SUPPLEMENTARY RESPONSE TO SUBMISSIONS SSD 10352

Moriah College
Staged Redevelopment

Prepared for
MORIAH COLLEGE
December 2020

Figure 3 – Required vegetated buffer zone – Annexure 2 of EPBC 2002/575

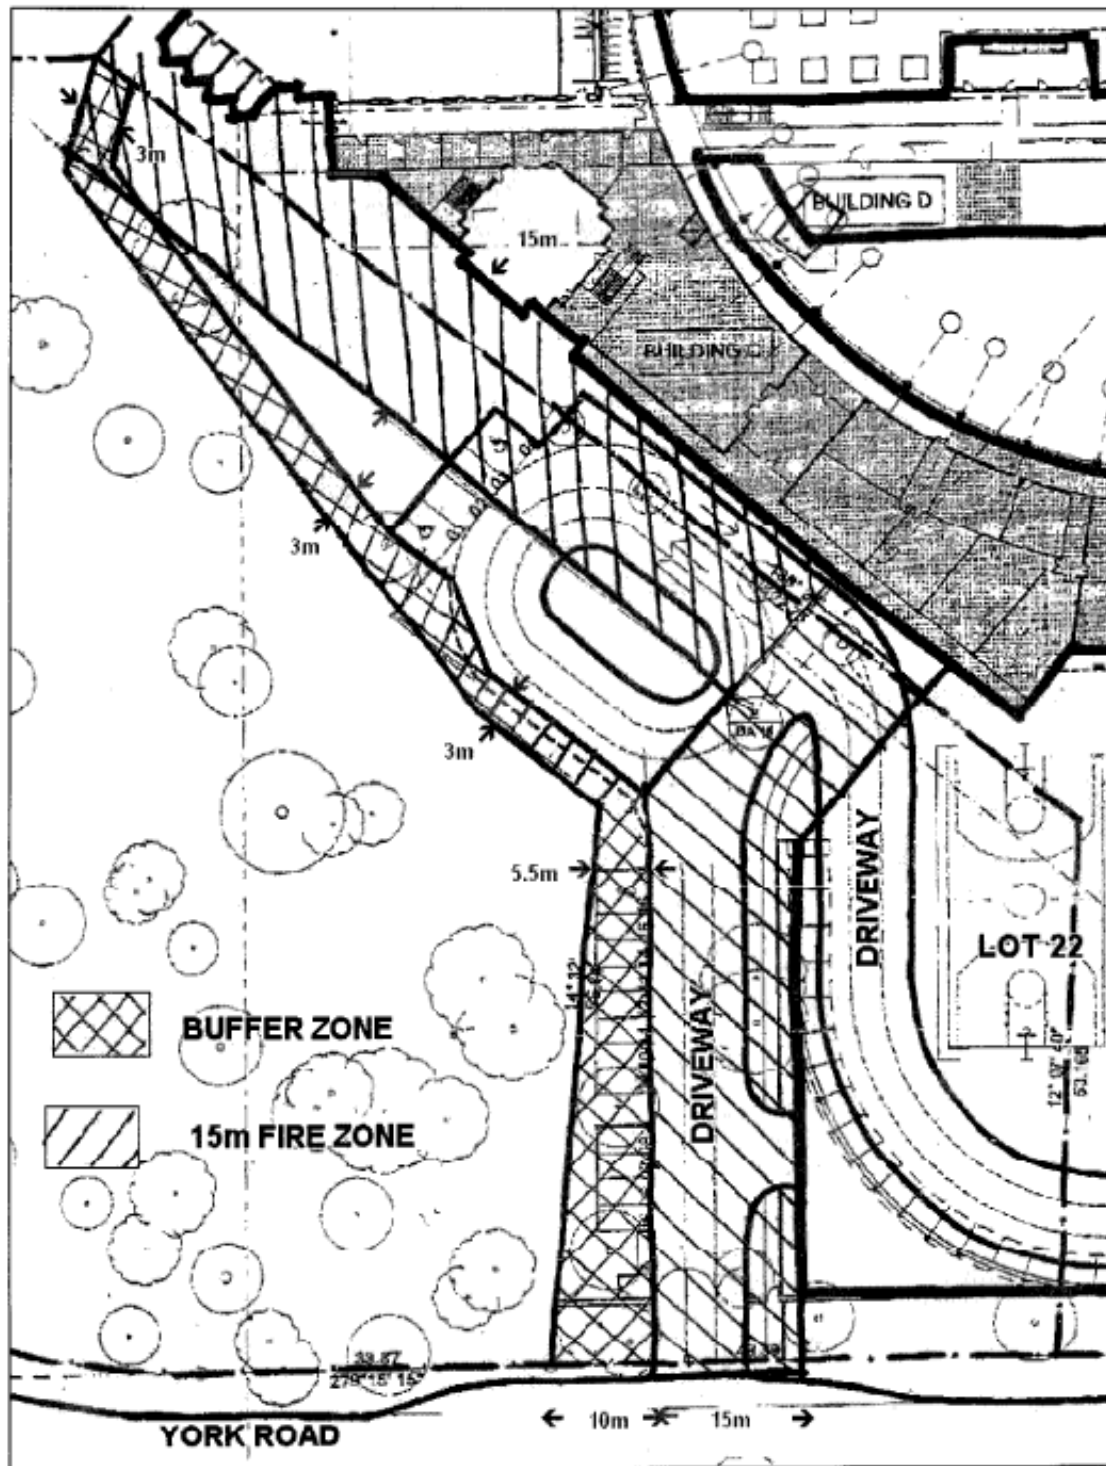
The proposal has been amended to accommodate a 3-10m landscape buffer zone along the western boundary of the site to the ESBS area located on Lot 23. The buffer zone is to be reinstated in accordance with the consent conditions stipulated by LD 282/00 granted by Waverley Council on 22 May 2001 and EPBC 2002/575 granted by the Commonwealth Minister for the Environment and Heritage on 25 October 2002.

- Rehabilitation of ESBS (either on Lot 23 or an “area of equivalent size and condition”), governed by an approved vegetation management plan.
- Provision in Lot 22 along the boundary with Lot 23 of a vegetated buffer zone as shown on the map (Annexure 2 of the approval – extract provided at Figure 3).
- Measures to prevent grass from landscaped other parts of Lot 22 entering the buffer zone.
- Fencing along the common boundary of Lots 23 and 22, the construction of which was to avoid impact on ESBS mature tree and shrub species (other than *Leptospermum laevigatum*) on Lot 23.
- No structures to be erected on Lot 22 that will cast shadow onto Lot 23.

It is understood the required buffer zone was established in accordance with the conditions of approval. However, overtime that buffer zone has been impacted by various structures and hard surfaces associated with the existing ELC and Astro turf playing fields.

- Existing timber deck to be altered and reduced in size to accompany the buffer zone
- Shade structure to be altered and moved 3.5m north east
- Open space area reduced in size to accommodate the buffer zone
- Existing Astro turf area to be reduced in size to accommodate the buffer zone.

Figure 6 Amended VMP Site Plan

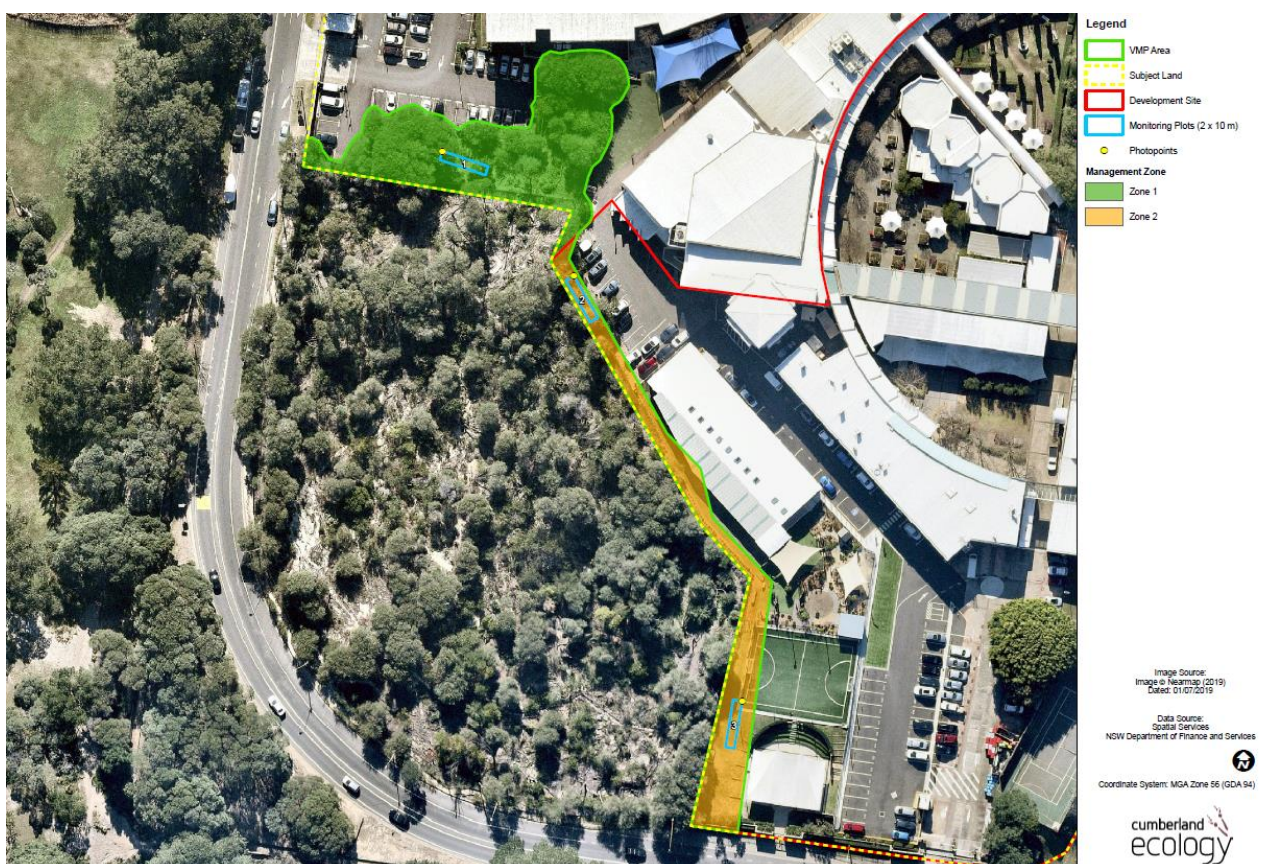
The amended VMP submitted with this SRtS creates two separate management zones within the Moriah College site (refer Figure 6), including:

- Zone 1 – Remnant ESBS (highlighted in green below)
- Zone 2: Buffer Area (highlighted in yellow below).

Due to the condition of the vegetation within zone 1, regeneration strategies are required in order to improve the condition of the ESBS. However, consistent with the Banksia Reserve VMP, no re-vegetation practises are proposed within the existing ESBS of the VMP Area. Re-vegetation practises are proposed only for Zone 2 with species consistent with ESBS and weed control activities will be carried out to assist regeneration of native plantings.
